CALIFORNIA COASTAL COMMISSION

STAFF REPORT: CONSENT CALENDAR**APPLICATION NUMBER: 5-00-413****APPLICANT:** City of Los Angeles, Dept. of Public Works**AGENT:** William Jones, James Doty

PROJECT LOCATION: Santa Monica Canyon Flood Control Channel: southwest of Short Street from the Santa Monica Canyon Flood Control Channel along approximately 300 feet of West Channel Road, south of PCH and east of Chataqua Blvd, Pacific Palisades, Los Angeles County.

PROJECT DESCRIPTION: Low flow diversion structure and pumping plant in concrete lined flood control channel to divert low, dry-weather flow from channel to sanitary sewer system. Project includes construction of a shaped concrete berm in the channel. A 10-inch force main, 4' by 10' trash collection area, a holding tank with pump, and an ambient gas detector, will be constructed below grade; and, in addition, a 6' high 4' wide 2' deep control box adjacent to channel, will be extend above ground. The project includes resurfacing West Channel road southwest of Short Street.

EXHIBIT NO. 2
APPLICATION NO.
5-00-43
Project Detail

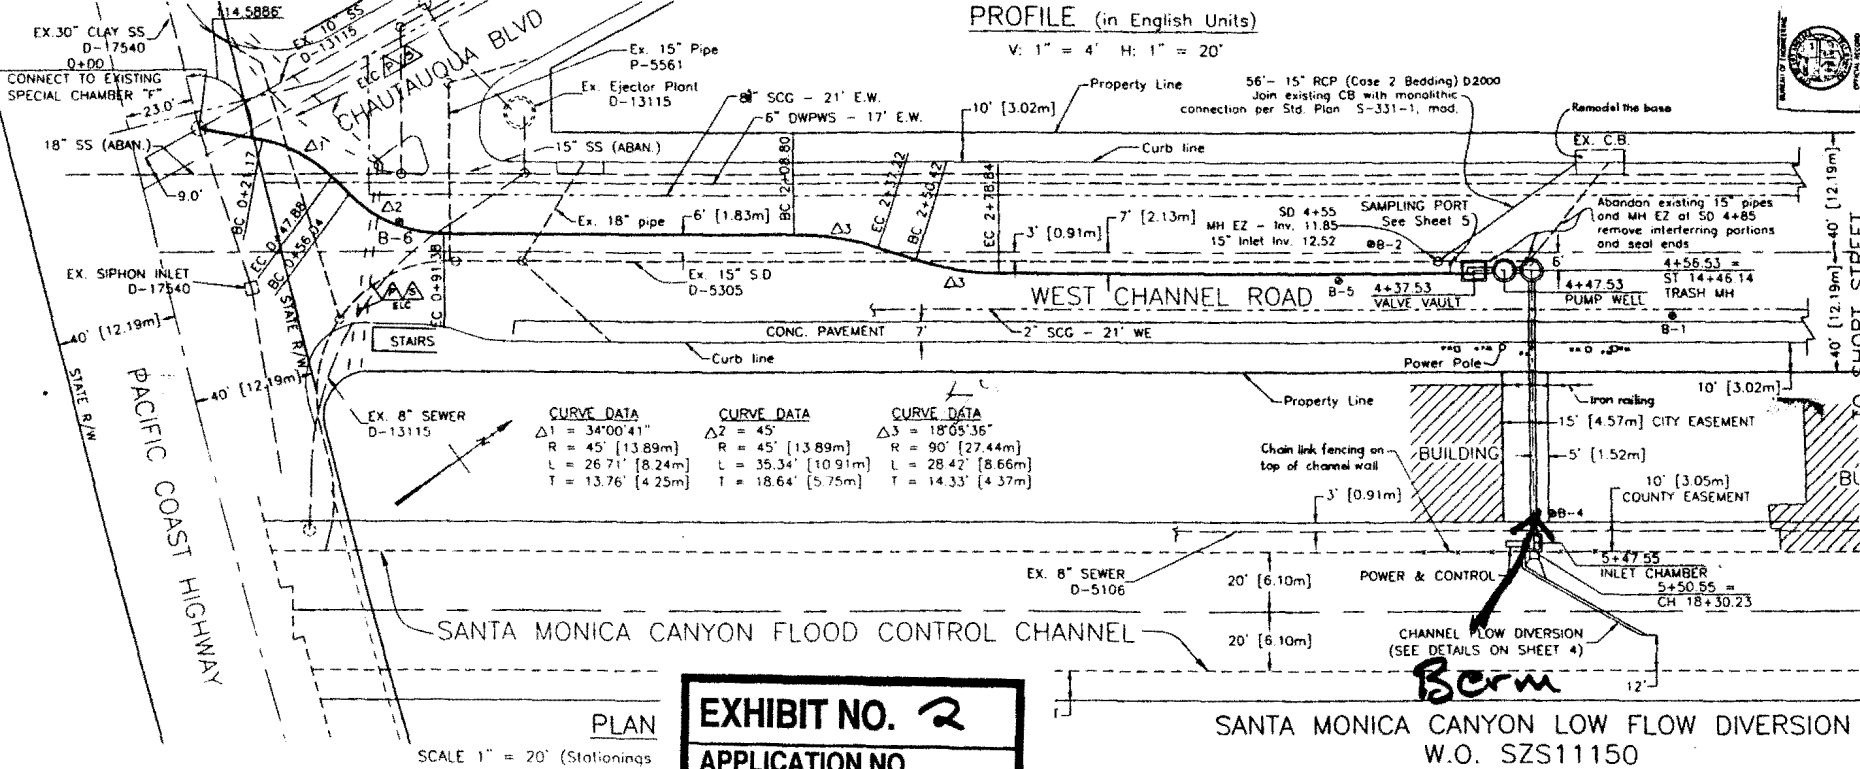
The project involves construction of a thirty foot wide one to one-and-a-half foot high shaped concrete berm across the channel. The berm will block low flow runoff diverting it into a 24-inch pipe, which will be located beneath a nearby commercial parking lot. The 24-inch pipe will flow into a pumping plant that contains a 4' by 10' below grade trash collection area. The plant will separate out the solids and discharge the liquids through a 10-inch force main to the Coastal Interceptor Sewer at Pacific Coast Highway. The Coastal Interceptor Sewer flows into Hyperion Treatment Plant. The project will also include an aboveground control box approximately 6' high, 4 feet wide and 2' deep. The box will be located adjacent to the flood control channel wall above the inlet pipe. The
